Research Report 1434

**Human Factors Assessment:  
Light Armored Vehicle,  
Maintenance/Recovery Vehicle (LAVM/RV)**

**Gregory S. Krohn**  
Essex Corporation

**December 1986**

Figure 3. The crane blocks the opening and closing of the rigger's hatch.

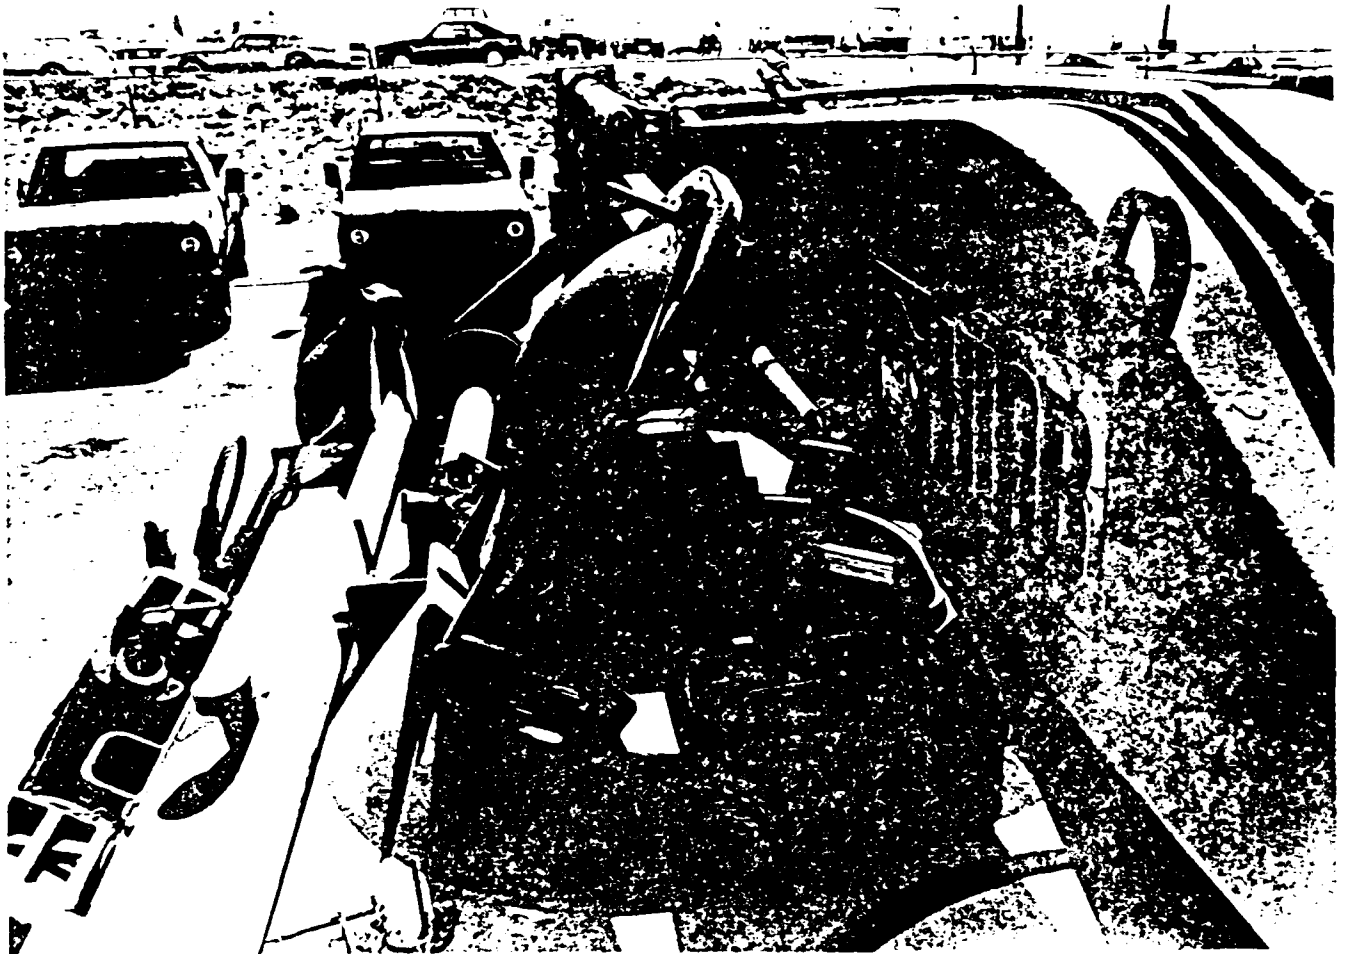
**Hatches and doors.** Sixty percent of the crew reported safety hazards involving obstructed hatches and rear doors. Figure 3 shows the crane blocking the rigger's hatch while Figure 4 shows the towing pintle blocking the rear doors. Both hazards prevented the rear crew positions from being occupied during testing when the vehicles operated "buttoned-up." The safety hazard also prevented the human factors specialist from obtaining instrumented measures of noise, ventilation and lighting under these conditions. Unless corrected, the crews cannot rapidly enter or exit the vehicle. Moreover, the rigger cannot button-up without operating the crane. The hazards become especially dangerous if the vehicle is being attacked or if evacuation is necessary.

- Lower pintle below rear doors.
- Add pivot hinge for driver's hatch.
- Add pivot hinge for rigger's hatch.
- Raise or change position of machinegun mount.
- Increase diameter of hatches.
- Add padding around hatch openings.
- Remove obstructions to vehicle passageways.
- Add nonslip surfaces to grill and steps/handholds.
- Protect hatch seals.
- Caution labels for hatch seals.
- Cautions about hatch seals in literature and training.

Figure 5. The M60 gun mount (above the open hatch) blocks the opening or closing of the driver's hatch.

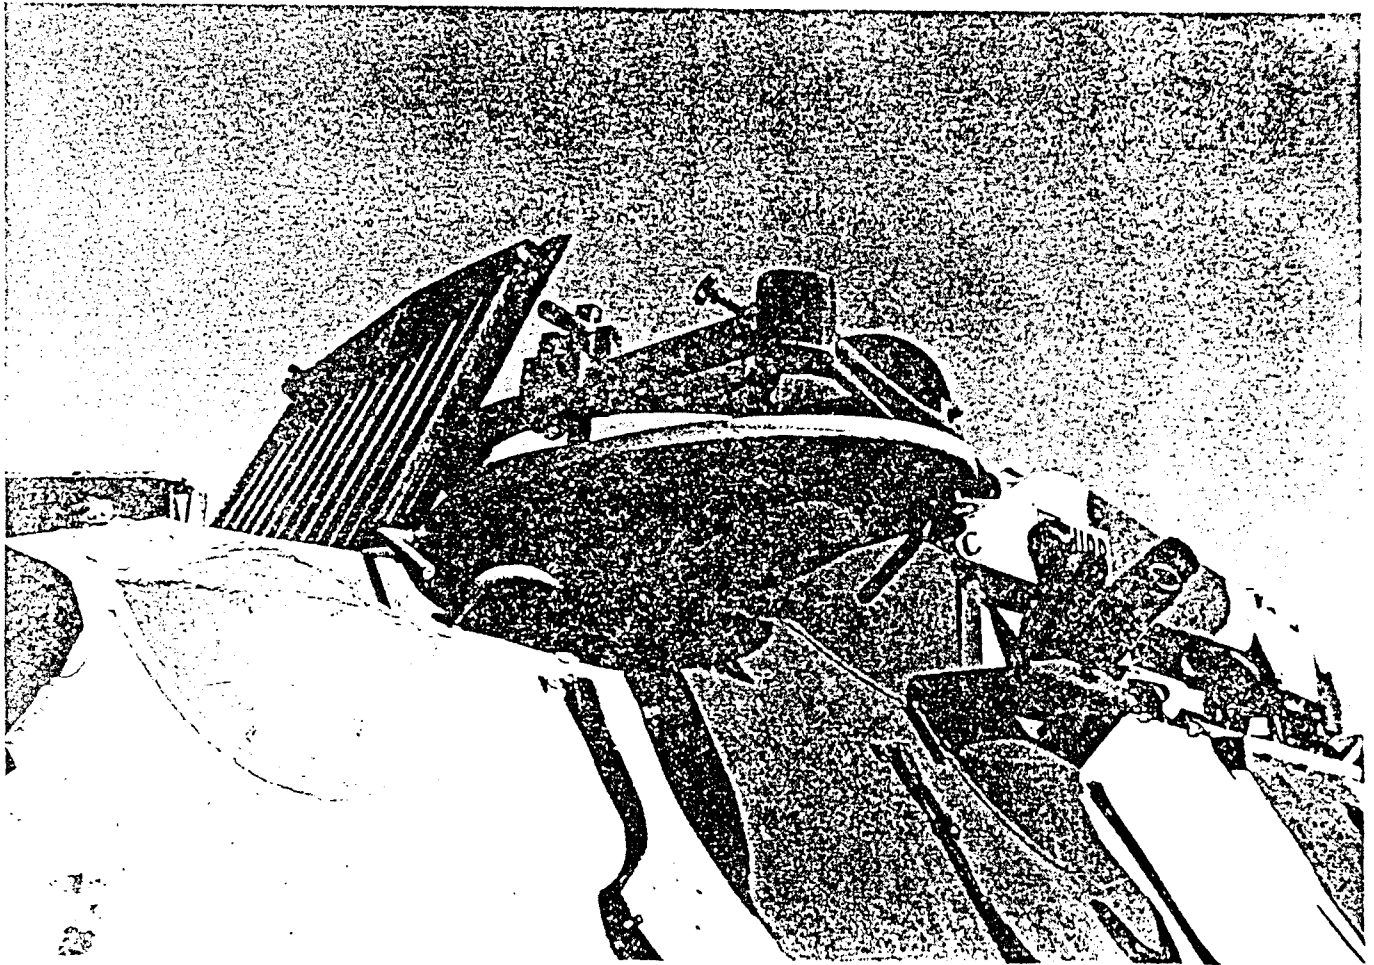
Additionally, both drivers reported that the M60 machinegun and mount, when traversed over the driver's hatch, blocks the hatch (see Figure 5). The gun and mount not only interfere with entering or exiting the driver's station but they also may endanger the driver's life when the gun is firing.

Figure 7. Power pack grills are without a nonslip surface.

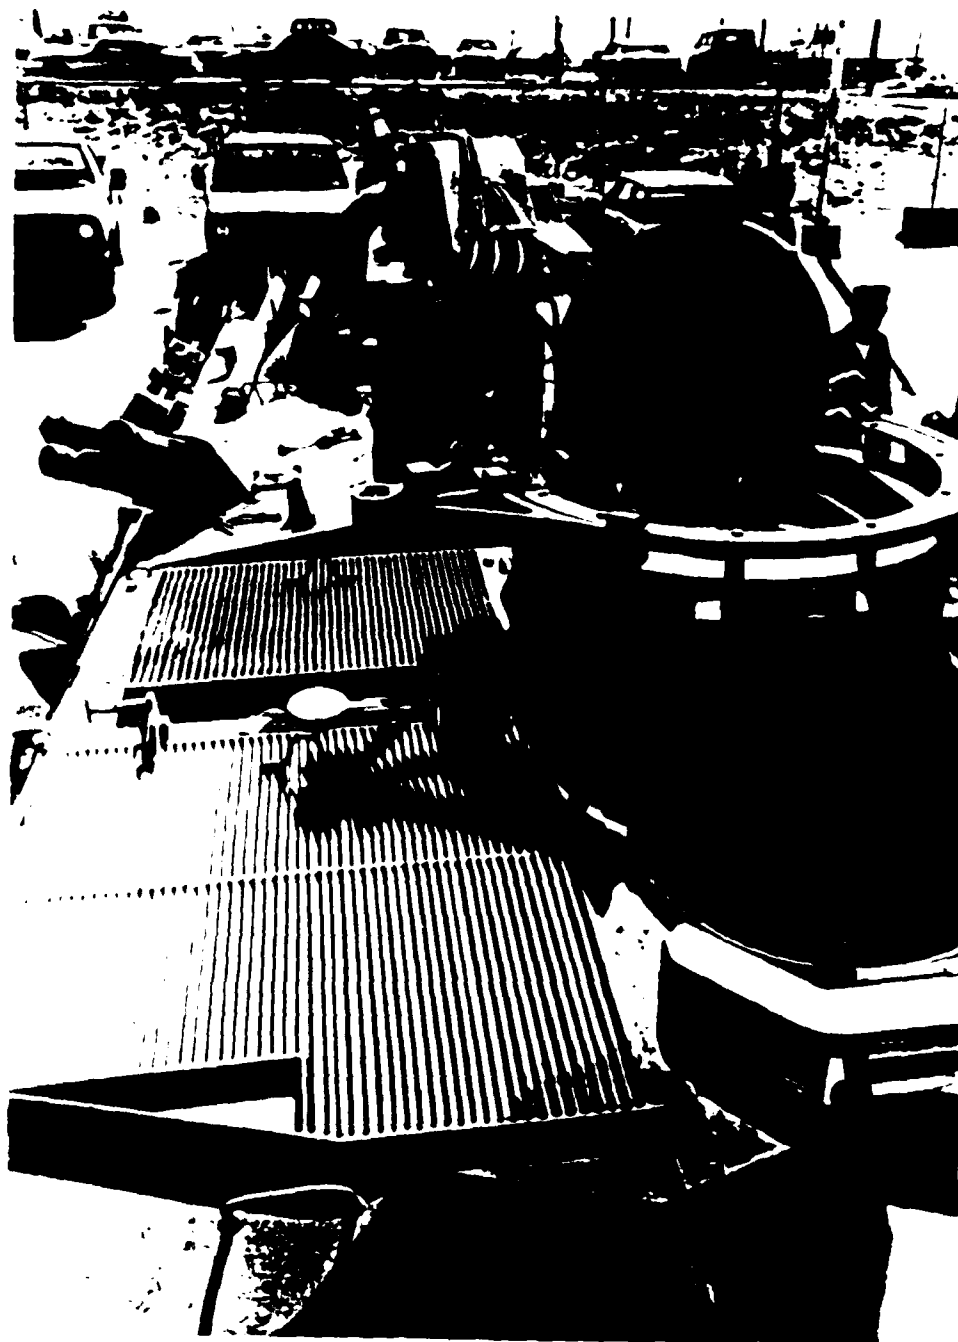
28.	Top walking surfaces	1	No friction producing surface on power pack grills.	Slip and fall injury likely when wet or oily.
29.	Steps and handholds	2	No friction producing or gripping teeth on footholds.	Slip and fall injury likely when wet, muddy, icy or oily.

Figure 8. The gear shift (left) and transfer case lock (right) are too similar and may be accidentally activated.

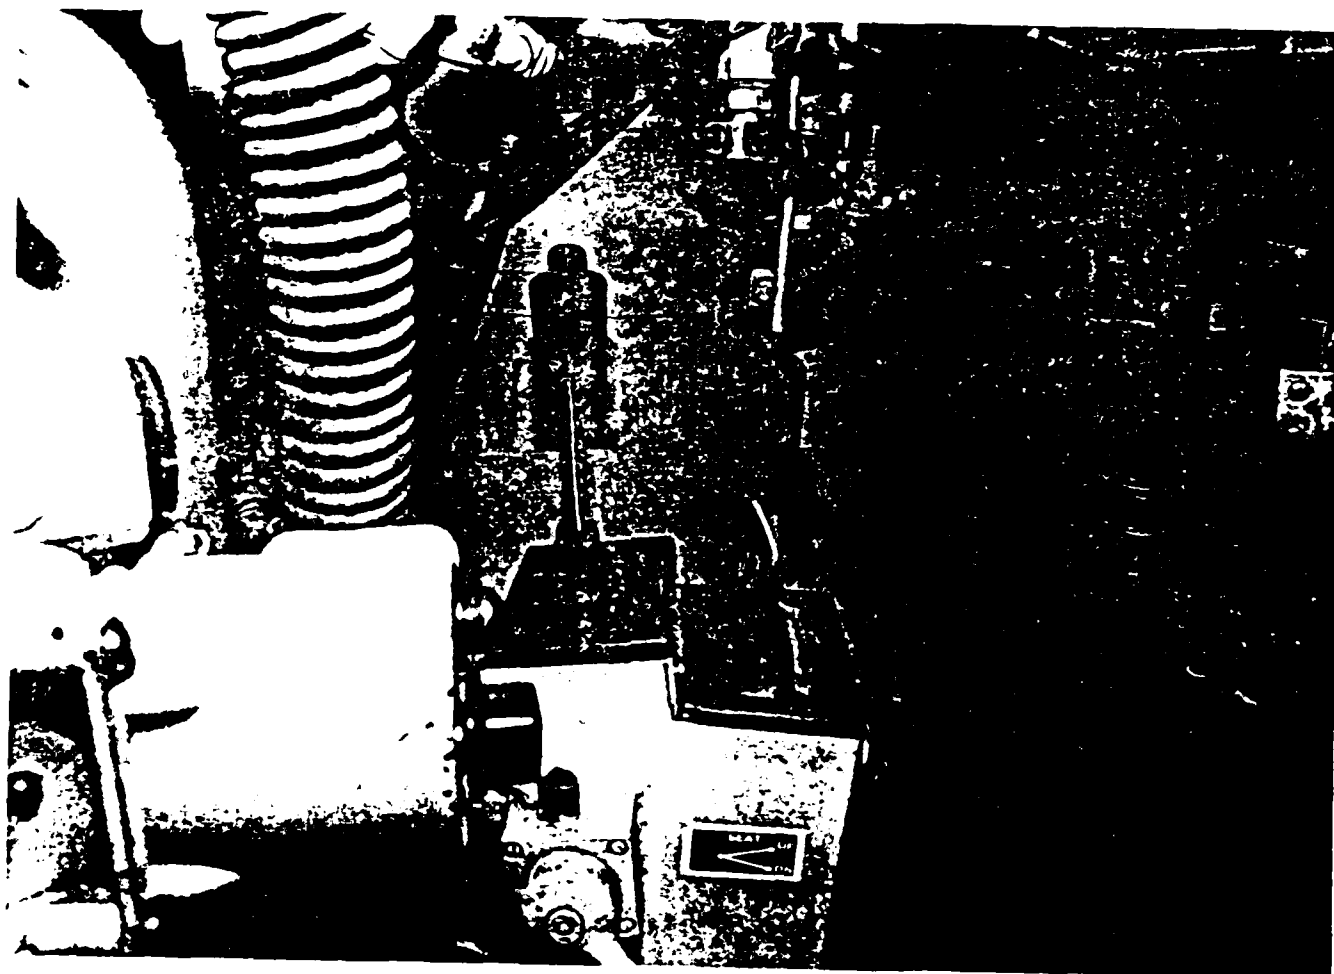
Driving controls. Both drivers interviewed reported several control/display location problems. Figure 8 shows the gear shift and transfer case lock levers. These control levels are identical and located to the driver's left side. The gear shift lever is on the left and is the farthest lever from the driver. It is also the most frequently used lever. The lever handles are approximately three inches apart. Human factors deficiencies include:

1. The drivers have difficulty determining which lever is in their hand by touch alone.
2. The drivers have difficulty determining which lever is in their hand by position alone. The levers are close together and one lever is slightly higher than the other. The driver's seat height has a wide range of adjustability in height (10.5 in (27 cm)). Thus, the lever heights relative to the driver's seated height change and are not reliable cues.
3. The less frequently used transfer case lock lever may be bumped by the driver's arm or hand when he tries to use the gear shift lever.
4. Accidental activation of the transfer case lever is likely to result in damage to the vehicle's drive train.

Design changes might include separating and relocating the control levers. In addition, position the gear shift lever closer to the driver than the transfer case lever. Change the knob configuration of the transfer case lever. A "T" handle shape might be a helpful shape code that distinguishes the transfer case lever and initializes its function.

Figure 10. The on-board crane control lever symbols are difficult to view.

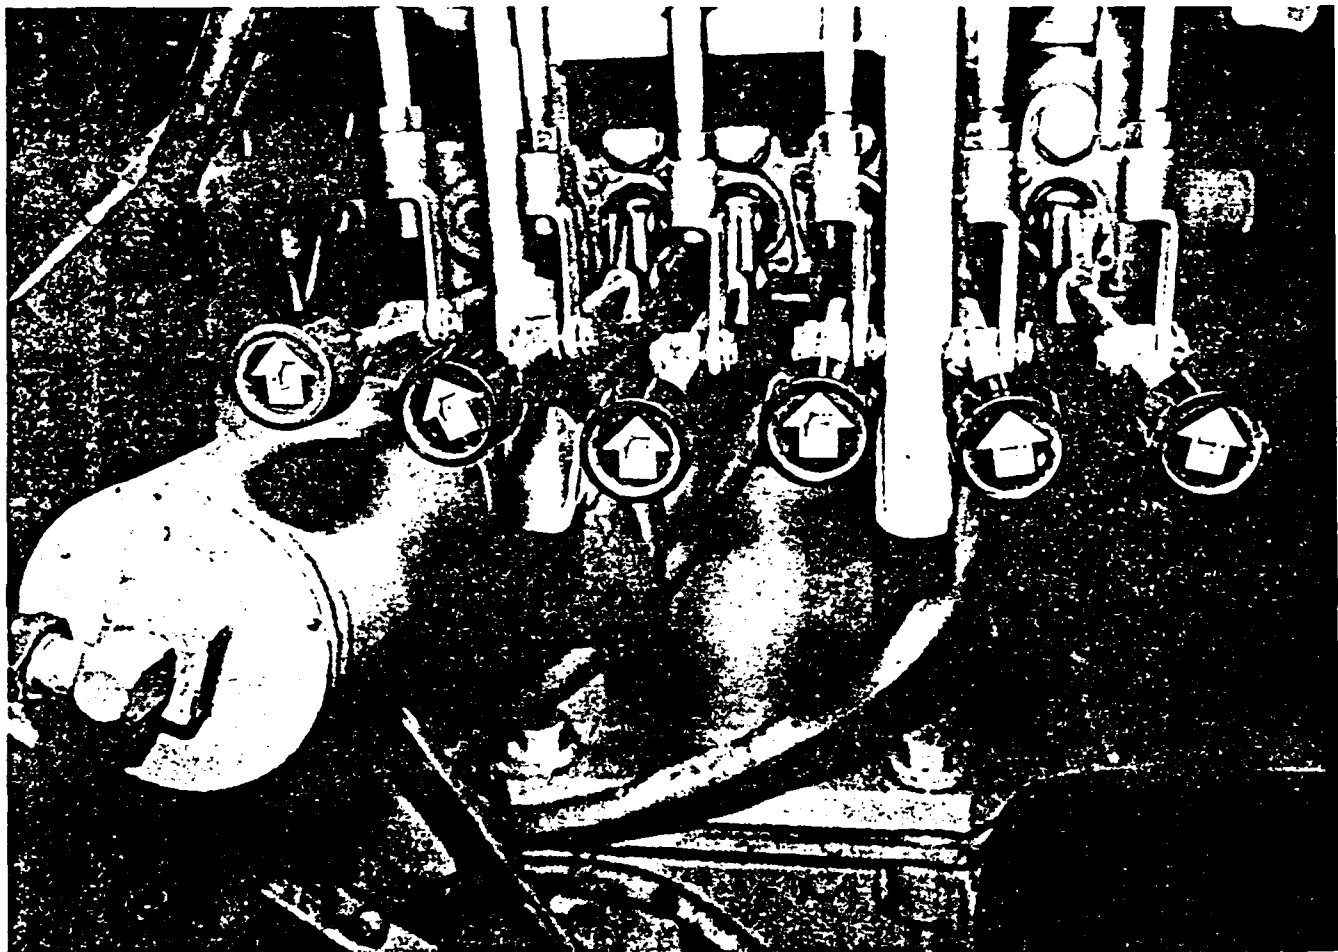
**On-board crane controls.** The crews rated the use of the on-board, base-mounted crane controls as borderline (mean rating, 3.3). Thirty percent of the crews felt that it was hazardous to use the on-board control because the crane cannot be viewed from the control station. Figure 10 shows the on-board control station and the symbols on the levers. The on-board controls will be used when the remote controls are inoperable, foul weather occurs, threat of combat occurs, or if a single, quick adjustment to the crane's stored position is necessary. The controls are located behind the commander's station and approximately seven inches above the vehicle floor. The controls have several human factors deficiencies, including:

1. The operator cannot view the crane responses to the control lever movements. The operator can see very little crane movement through the periscopes. Moreover, the operator's head height when handling the control levers is approximately 20 in (51 cm) below the open hatch level. Finally, the control levers are 119 in (302 cm) from the rear doors, making it impossible to view the crane's movement.
2. The control symbols are too small to be easily viewed. The symbols within the larger arrows are less than one-quarter inch in height. The symbols cannot be seen in low light or blue light conditions.

3. Control lever activation directions are the opposite of the machine response directions. Activating the inner and outer arm levers by moving them up causes the inner and outer crane arms to move down (the control levers are the second and third levers from the left in Figure 10).
4. The control knobs become unscrewed and often symbols point in incorrect directions.

Human factors deficiencies such as those listed above are likely to increase task completion time, errors, and may result in equipment damage or injury. All crane control levers should move in the same general direction as the crane functions they control. Design changes might include reversing (if possible) the position of the input and output hydraulic lines on the manifold for the inner and outer arm levers. Place larger control symbols directly in line with the control levers on the valve manifold housing (not shown in Figure 10). It may also be possible to turn the valve manifold over, appropriately switching the input/output lines, so that the control levers are closer to the commander's hatch and can be activated in the appropriate directions. This would also place the control symbols closer to the overhead light.

Figure 11. The equipment carried inside the vehicle. Additional combat gear is not shown.

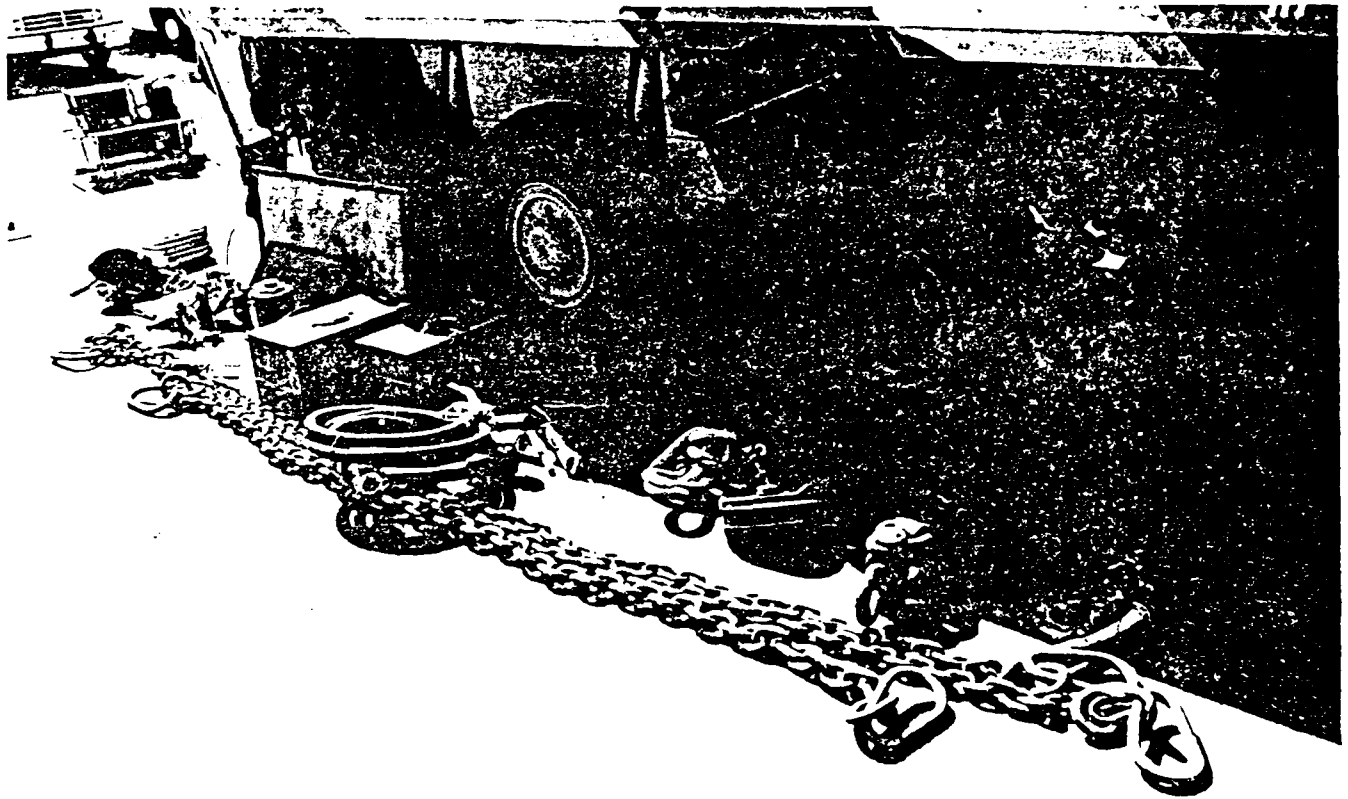
**Tool and accessory storage.** Crews rated the size and location of storage and the protection of equipment in storage as borderline (average mean rating, 3.1, see questionnaire items 43 to 46). Figure 11 shows the equipment carried in internal vehicle storage locations. Figure 11, however, does not show any combat gear which is also stored inside the vehicle. Figure 12 shows the equipment as it is usually stored in the vehicle. Notice that stored equipment is blocking the passageways. Figure 13 shows two of the three secure storage spaces allocated for all the equipment shown in Figure 11. Secure storage consists of two equipment trays (measuring 26 x 7 x 7 in (66 x 18 x 18 cm)) and one tool box (measuring 19.50 x 13.25 x 10 in (50 x 34 x 25 cm)). The lack of secure storage locations results in the stacking of equipment in any available space. The crew also reported that they stored equipment in their seated legroom and carried equipment in their laps when the vehicle was combat loaded. The lack of secure storage results in several problems, including:
